ADDENDUM NO.: ONE

DATE OF ADDENDUM: July 17, 2012

**Simulation Center
Camp Niantic
BI – Q – 661**

NIANTIC SIMULATION CENTER - CONCEPT PLAN

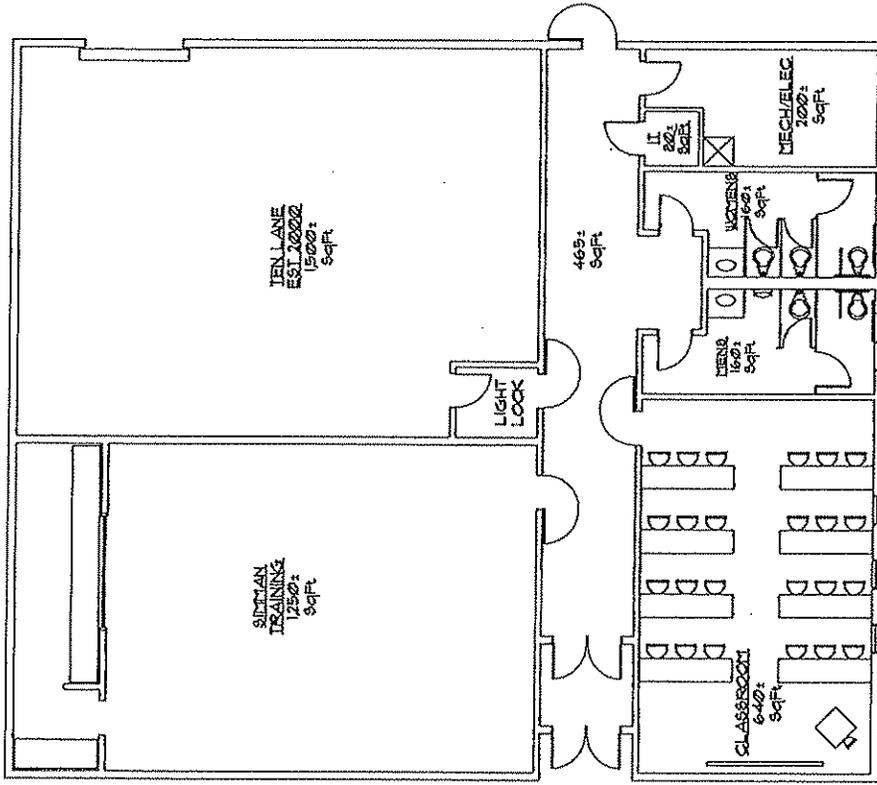
D. RFP Part 6 Attachment C-5

1. Replace drawing with new drawing attached to this Addendum

NOTE:
 BUILDING MAY BE BUILT UNDER
 ONE ROOF OR WITH TWO ROOFS
 PER CONCEPT RENDERINGS.
